STAFF RECOMMENDATION

**201 Broadway
September 21, 2016**

Application: New construction
District: Broadway Historic Preservation Zoning Overlay
Council District: 19
Map and Parcel Number: 09306209900
Applicant: Old Town Trolley Tours of Washington, Inc.
Project Lead: Robin Zeigler, robin.zeigler@nashville.gov

Description of Project: The applicant is seeking approval of construction that has already taken place without a Preservation Permit. The project includes resurfacing the parking lot, 5 flag poles, an ATM structure, food and ticket-sales trailers and food trucks on a corner lot.

Figure 1: Parking pay machine installed prior to overlay.

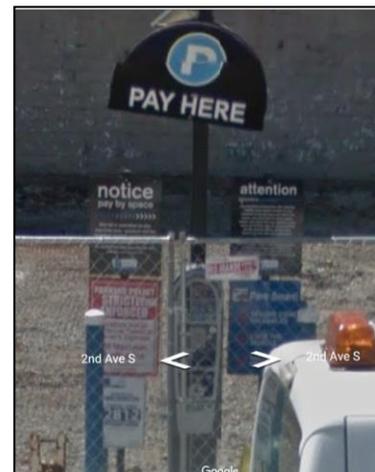
The parking pay machine and curb cut on Broadway were constructed prior to the lot being added to the overlay. (See figure 1.)

SITE LAYOUT PLAN

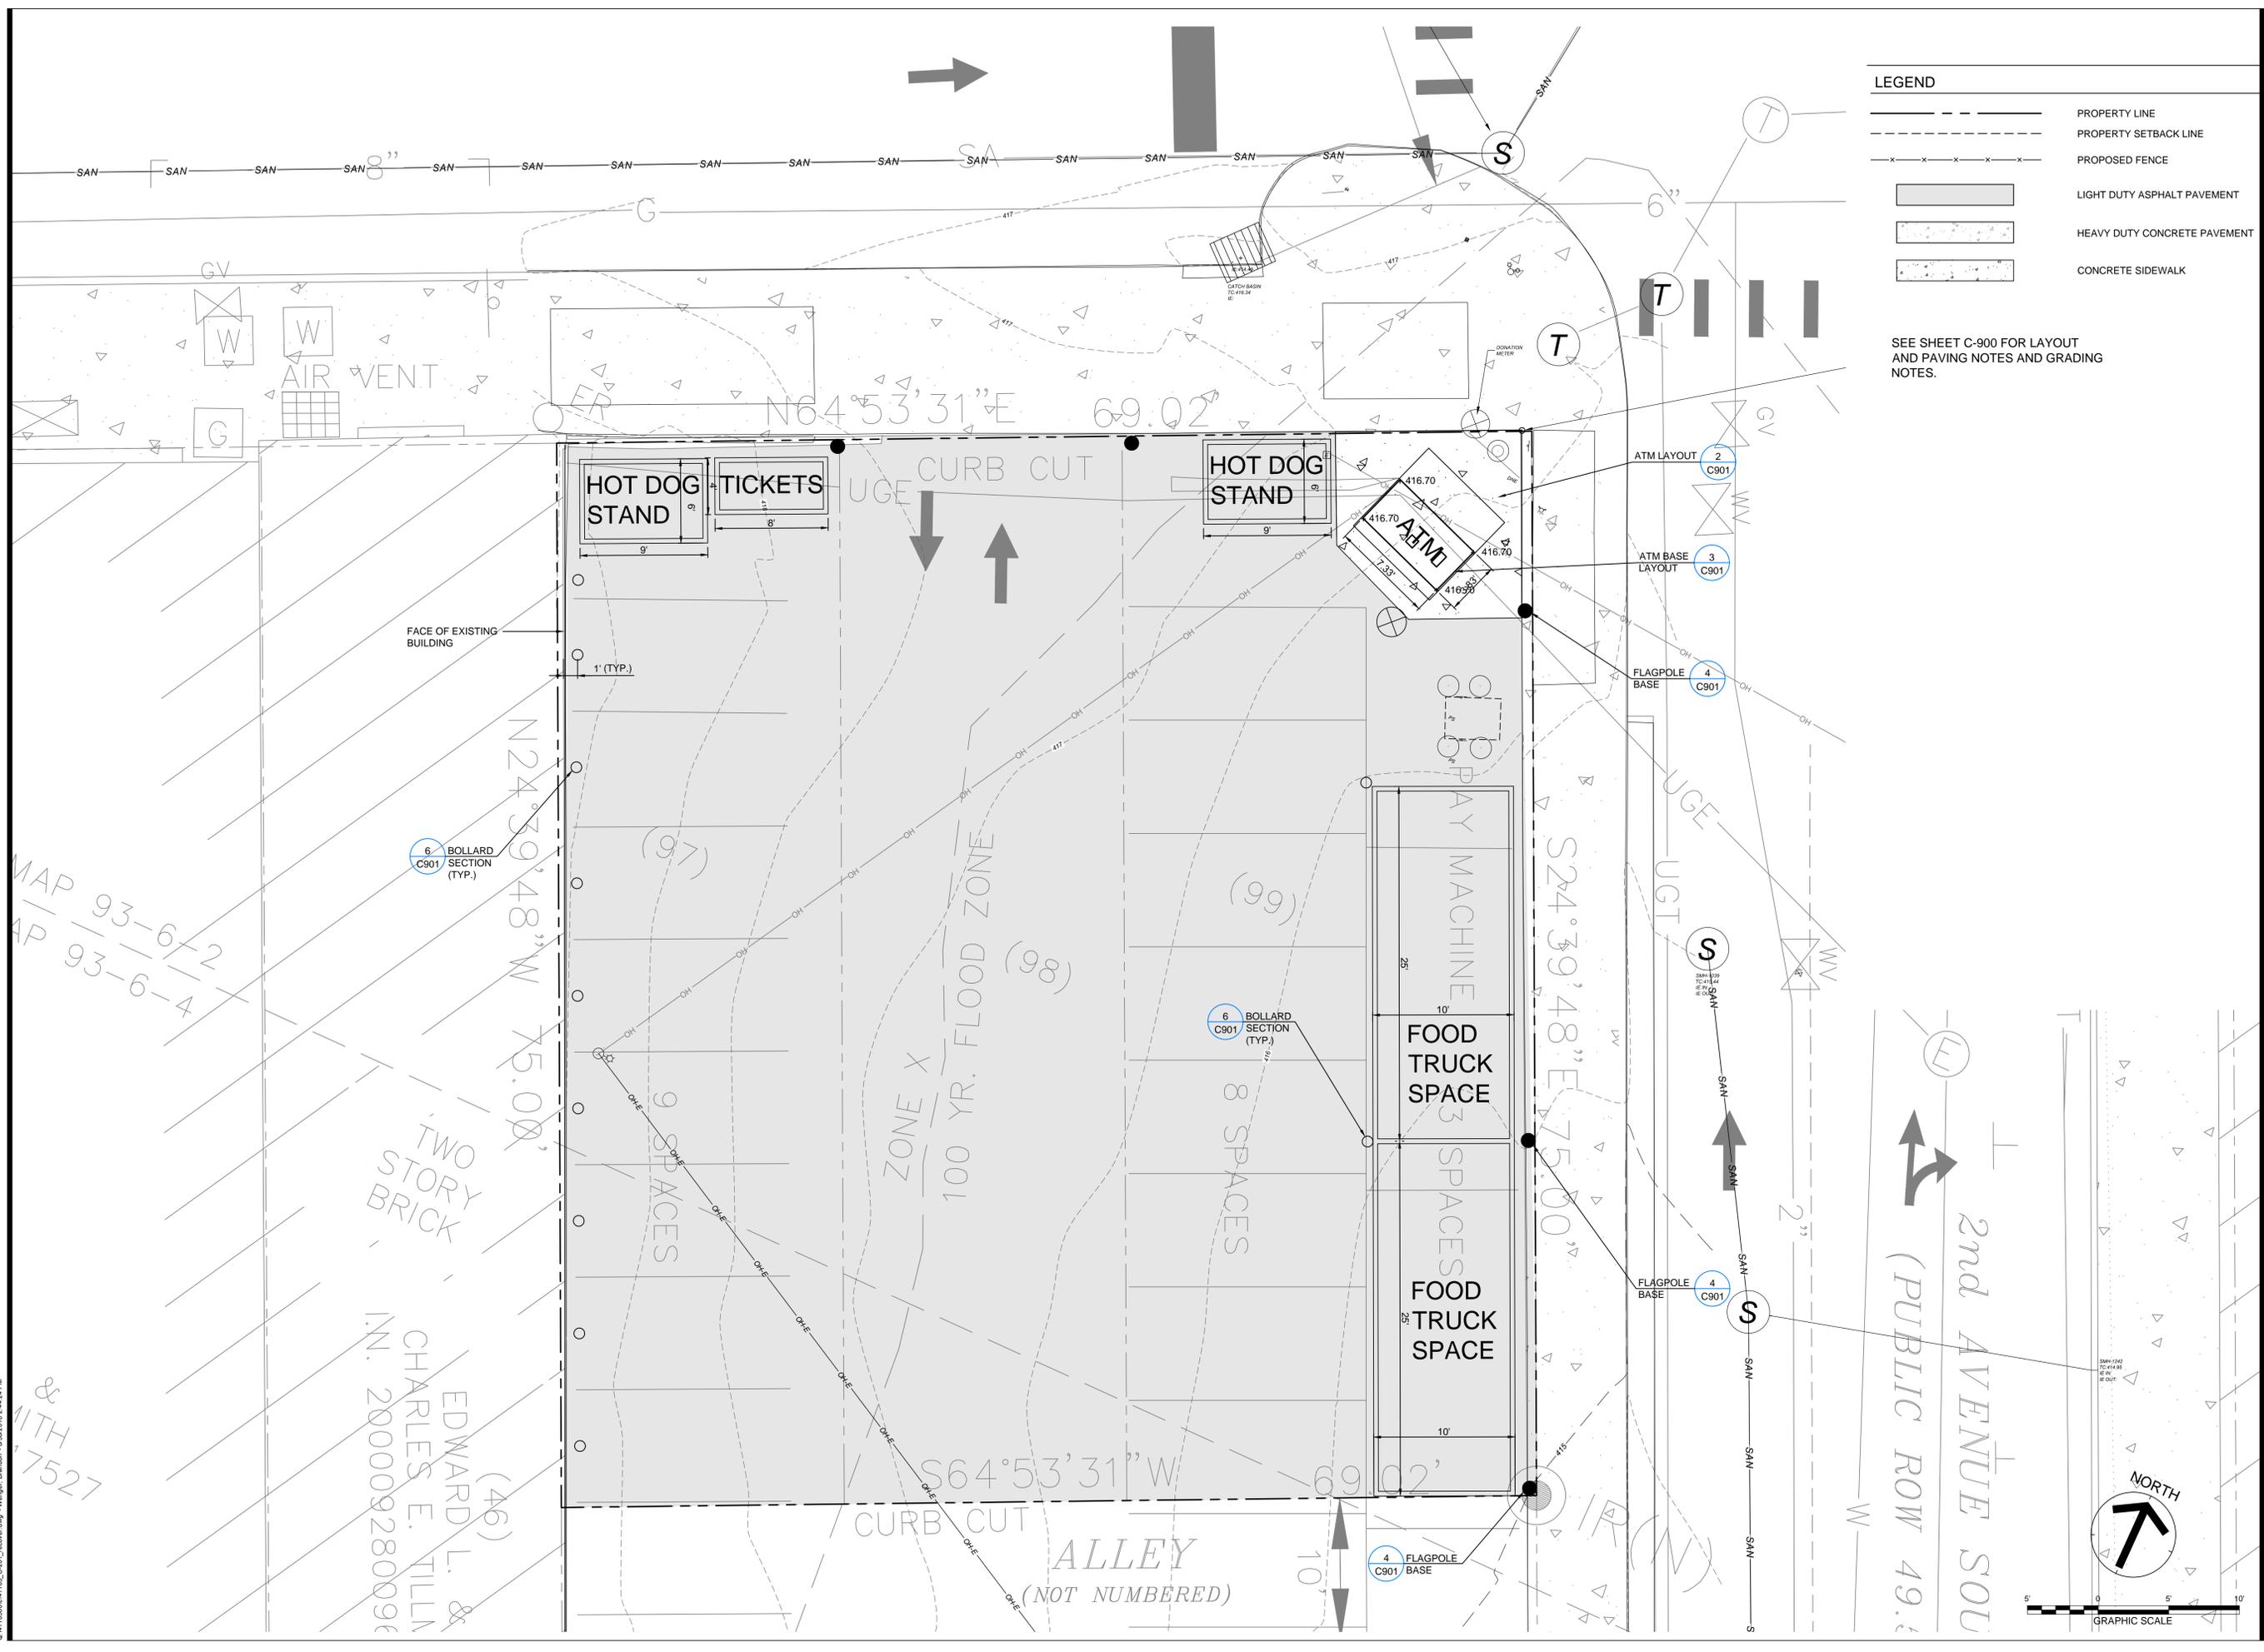
The ATM surround is seven feet and four inches wide (7’ 4”) and ten feet and six inches (10’ 6”) tall. It is covered in an adhered photo mural and includes internally lit signage as well as lighting beneath the cover. Signage is included directly above the machine itself.

General Principles, Section III states that “new construction should be consistent with existing buildings along a street in terms of height, scale, setback, and rhythm; relationship of materials, texture, details, and color; roof shape; orientation; and proportion and rhythm of openings.” The historic streetscape includes a minimum of two-story buildings with walls that extend the full width of the lot, store-front windows and upper-level punched-openings. The ATM does not create the solid rhythm established by the historic buildings.

Since the project does not include a building, it was more specifically reviewed under design guideline III.I for “parking/parking structures, plaza, arcades, landscape and open spaces.” Parking/parking structures, plaza, arcades, landscape and open spaces are only appropriate when the “design of such development contributes to the overall character of the district and streetscape and the new construction is consistent with the design guidelines for new construction.” As reviewed above, the proposal does not contribute to the overall character of the district and the streetscape, nor is it “consistent with the design guidelines” for new construction as it does not meet “General Principles” of section III for new construction.

In addition to not meeting the design guidelines for new construction, the ATM does not meet the policy the Commission established in 2004 that only allows for ATMs inside a building, where it would not be reviewed, or “in an alcove not on the primary facade.” Since there is no building, there is no alcove in which to place the ATM. (In addition, free-standing ATMs would not likely be approved by other departments. Please see “Department Comments.”)

The ATM includes signage. Signage, not associated with a building, does not meet the design guidelines. The size allotment for any sign, whether or not it is attached to a building, is based on the width of the building. Since there is no building, there is no allotment. The guidelines allow for poles signs for parking lots, where there is no associated building and the lot has a parking lot pole sign that was installed prior to the expansion of the overlay.

Staff recommends disapproval the ATM finding that the improvements do not meet Section III of the design guidelines for new construction or Section IV for Signage.
